SERVICE BULLETIN

MODEL BD-700-1A10 (BD-700)

**MODIFICATION – HORIZONTAL STABILIZER –
 ADDITION OF DRAINAGE HOLES TO ELIMINATE WATER ACCUMULATION AND
 ADDITION OF RIVETS ON THE ACCESS PANELS NUTPLATE ASSEMBLIES**

SERVICE BULLETIN: 700-55-004 **ISSUE:** Basic **DATED:** Jul 26/2002

KGC991-1098
Kit - Gang Channel Instl, Shroud Panels, H/Stab
(Sheet 1 of 2, Rev. C - continued)

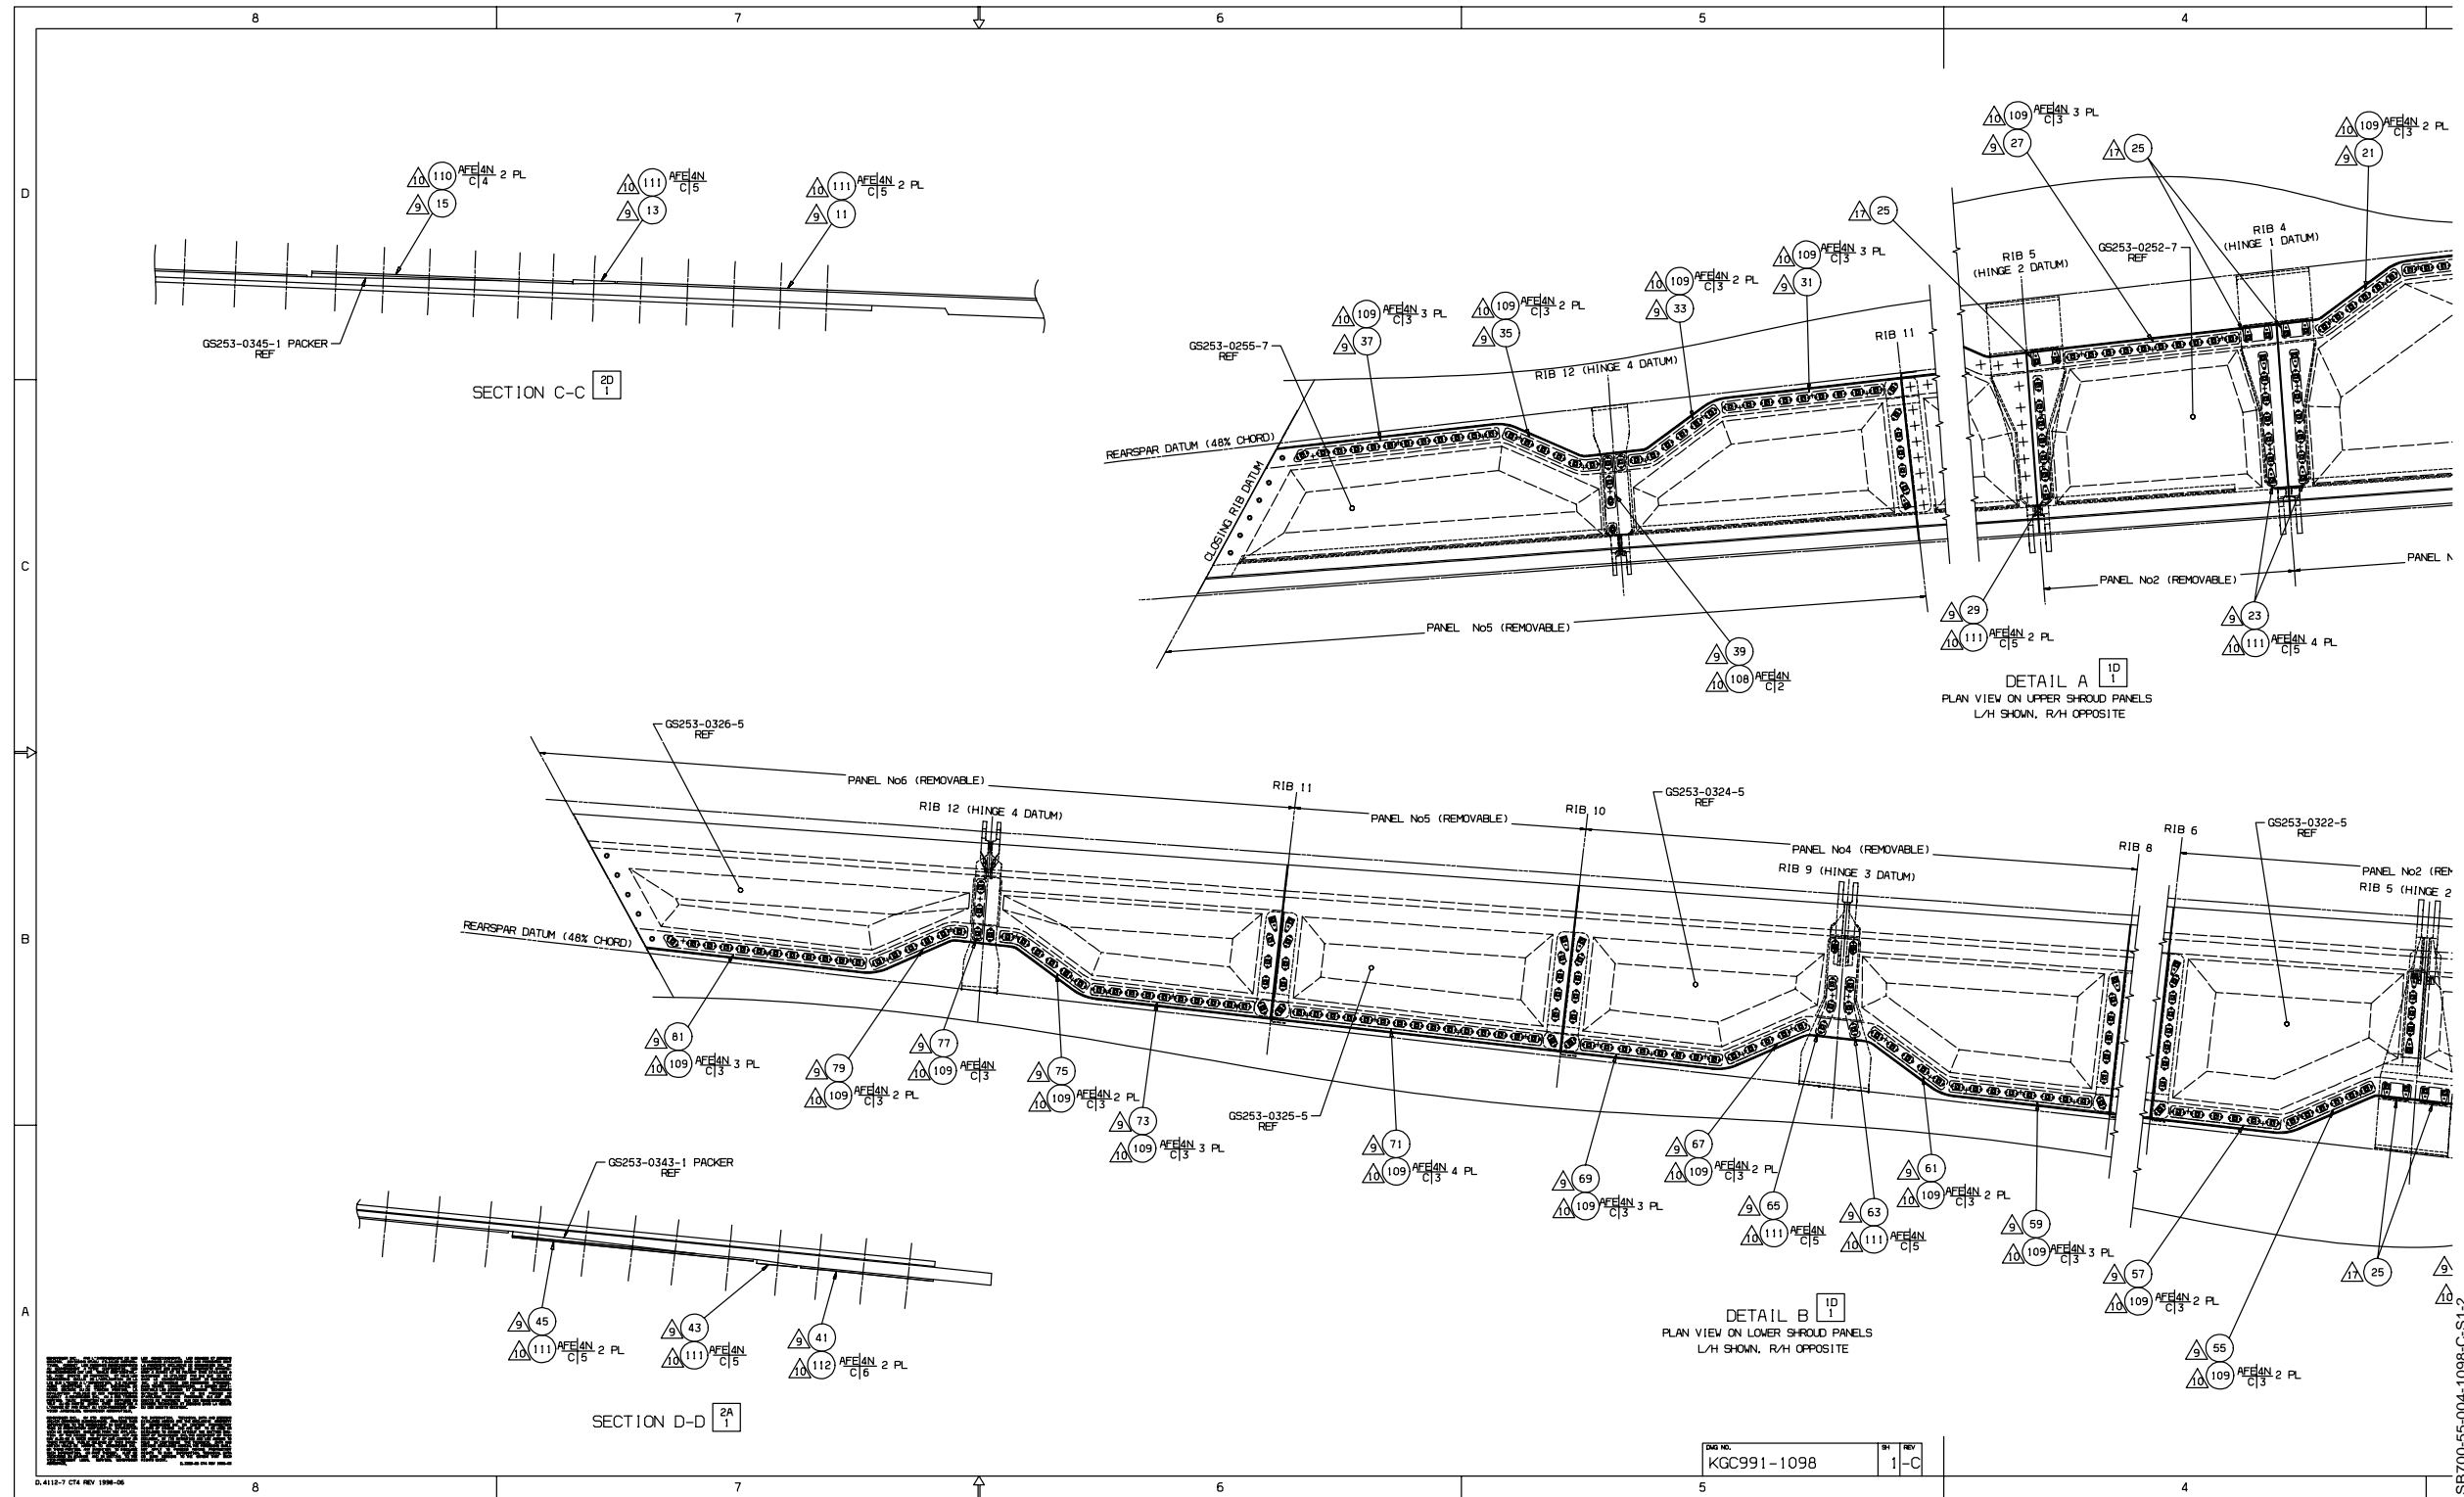
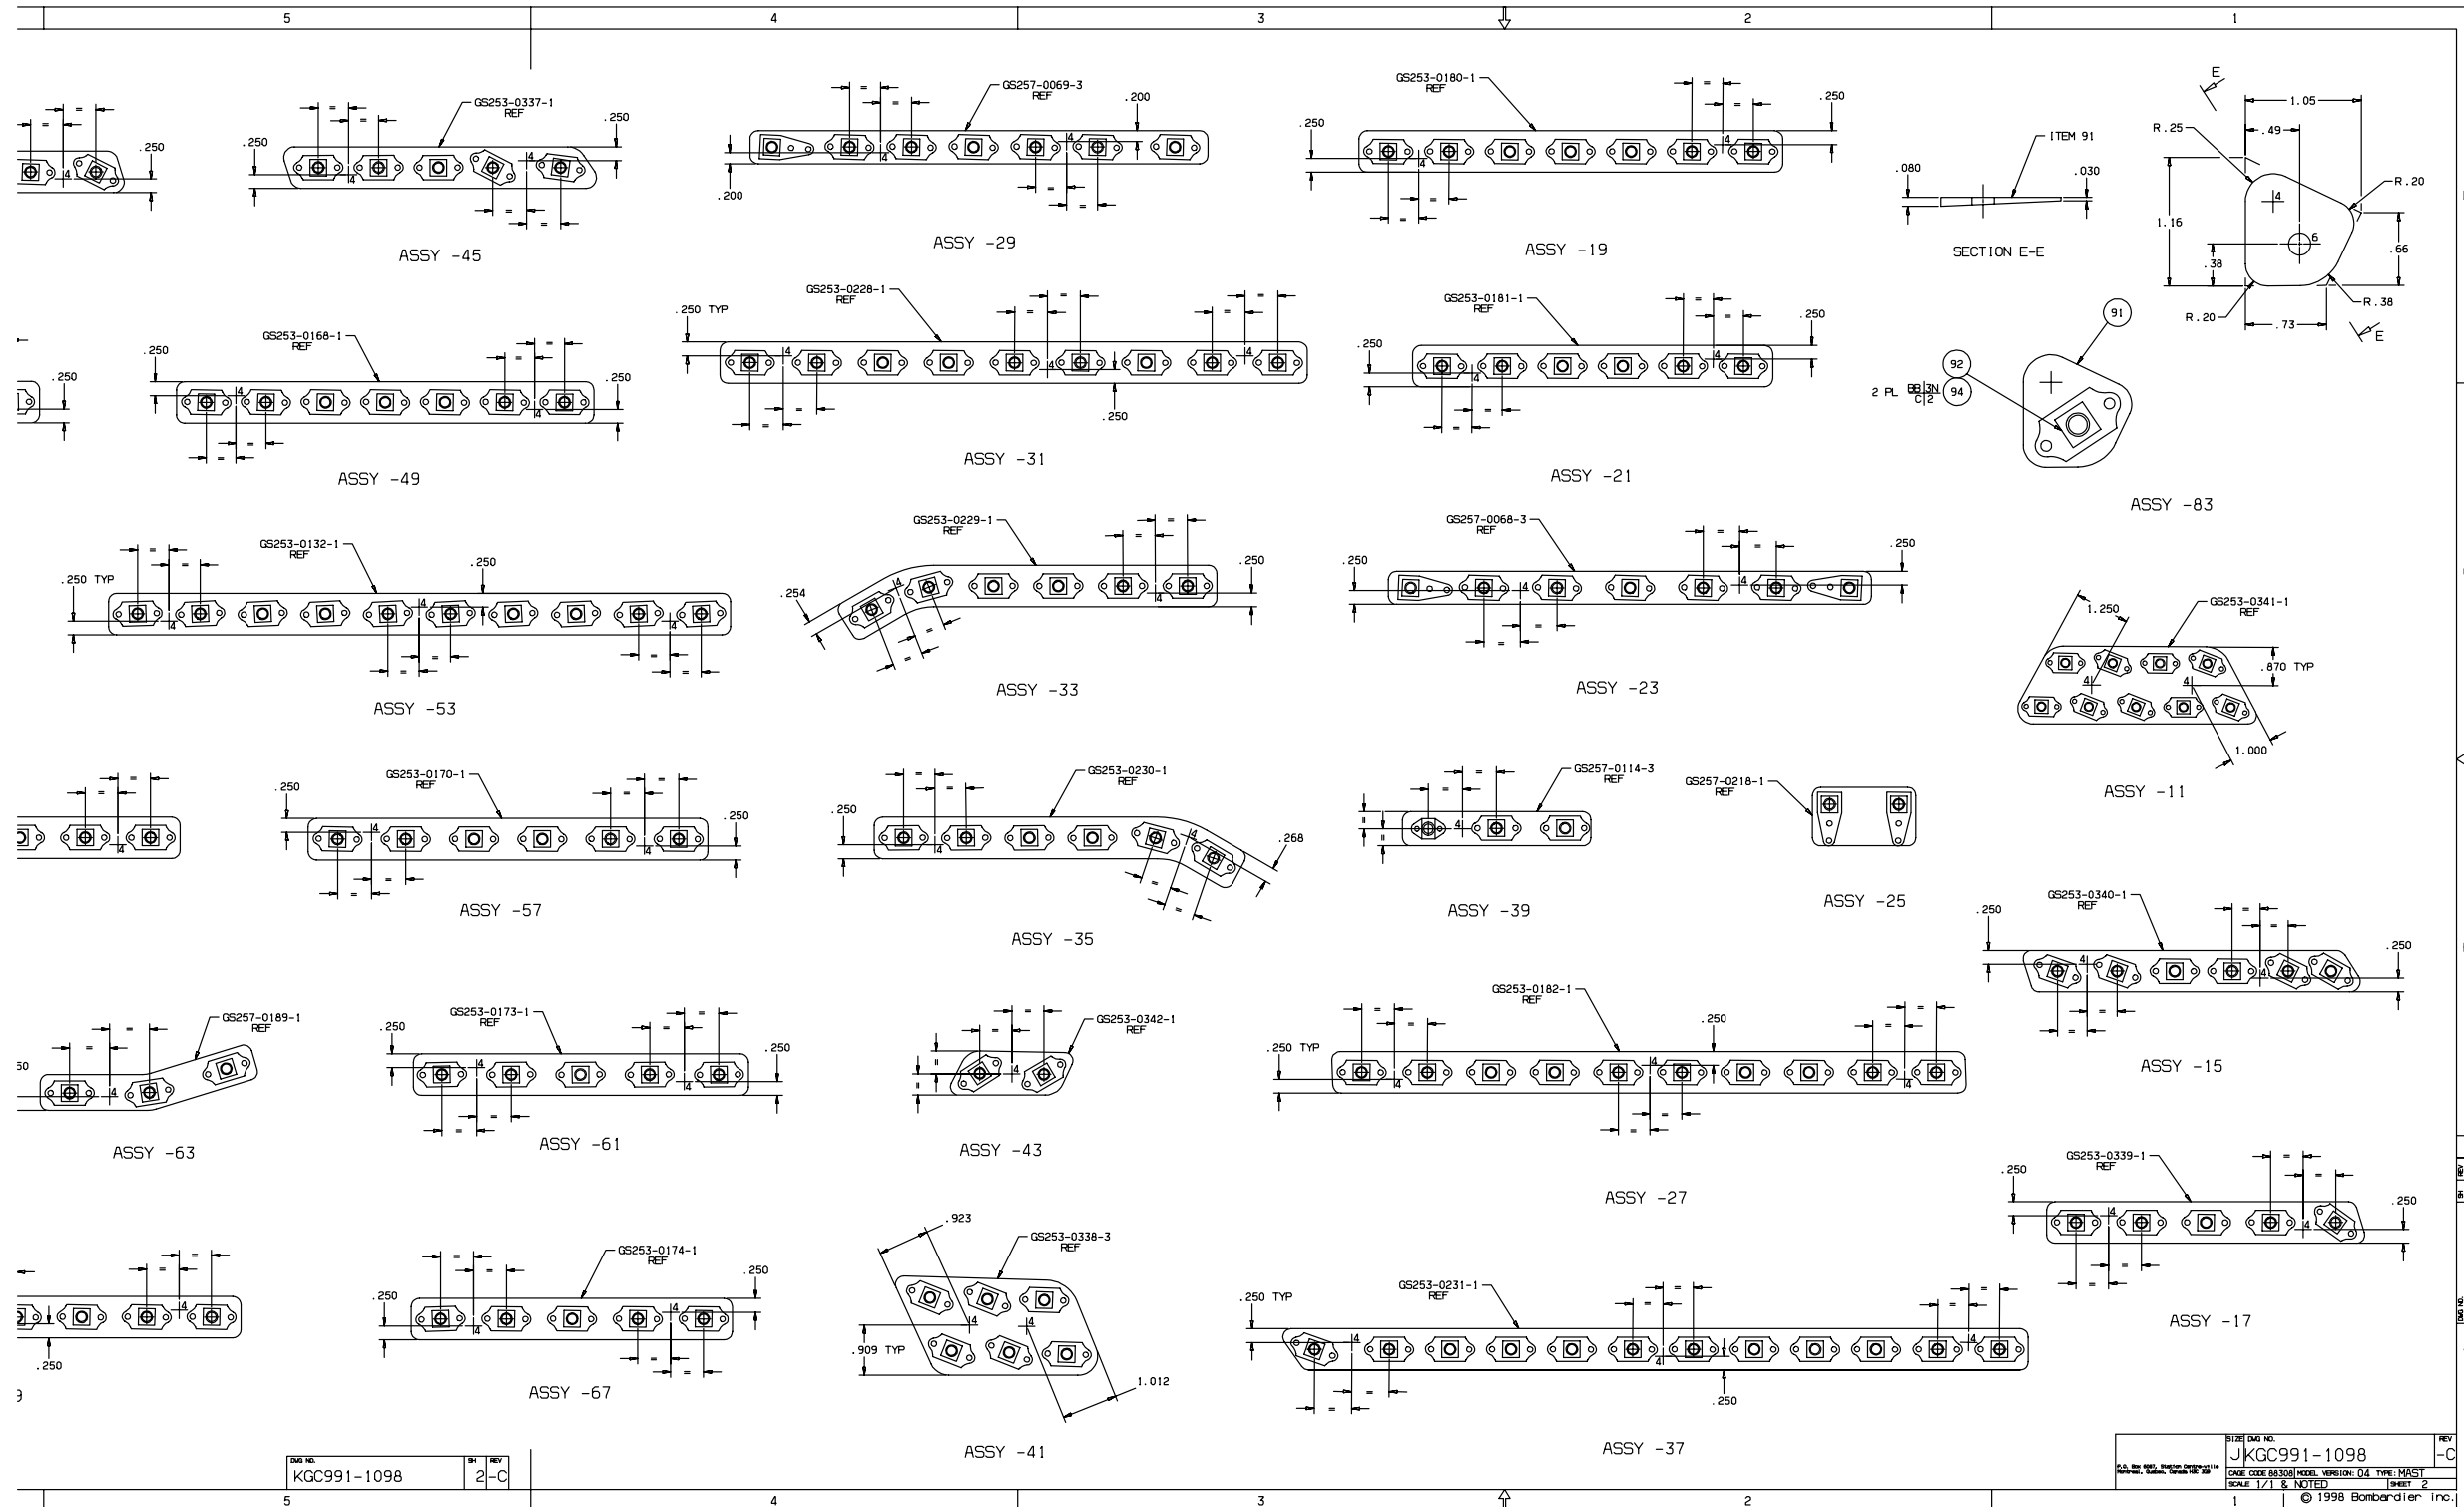
Nutplate assemblies are bonded to the horizontal stabilizer structure. During screw installation, the shroud panels of the nutplate assemblies (gang channels) easily come unbonded from the horizontal stabilizer structure. PART B of this Service Bulletin gives instructions to add an inter pitching of rivets to give more rigidity and prevent the gang channels from coming off.

- Get access to the horizontal stabilizer, and
- Do the modification of the gang channels as per Kit Drawing KGC991-1098.

- (3) Do the modification to the nutplate assemblies as given in the Kit Drawing KGC991-1098.

NOTE: Cold bond nutplates strip KGC991-1098-25 using epoxy EA9345 A/B or EA9309.3 A/B. Refer to TASK 51-21-53-340-801.

7. ~~Ø~~ DRILL HOLE Ø.25 ±.004 TO BD700 SRM CHAPTER 51-41-04.
8. ~~∅~~ DRILL HOLE TO BD700 SRM CHAPTER 51-42-08 TO SUIT 1/8 RIVET.
9. FOR ALL UNBONDED & PARTIALLY UNBONDED NUTPLATE STRIPS, REAPPLY ADHESIVE EA9345 AS PER BD700 AMM CH. 51-22-00.

10. THRU NUTPLATE ASSY AND H/STAB STRUCTURE, EXCLUDING SHROUD PANELS.
11. INSTALL RIVETS PER BD700 SRM CHAPTER 51-42-08.
12. ~~WET ASSEMBLE (INCLUDING FASTENERS) PER BD700 SRM CHAPTER 51-23-04.~~

16. IT IS PERMISSIBLE TO USE CR2662CW RIVETS IN LIEU OF CR4622CW.
17. COLD BOND NUTPLATES STRIP ITEM -25 USING EPOXY EA9345 A/B OR EA9309.3 A/B AS PER BD700 AMM CH. 51-21-53.
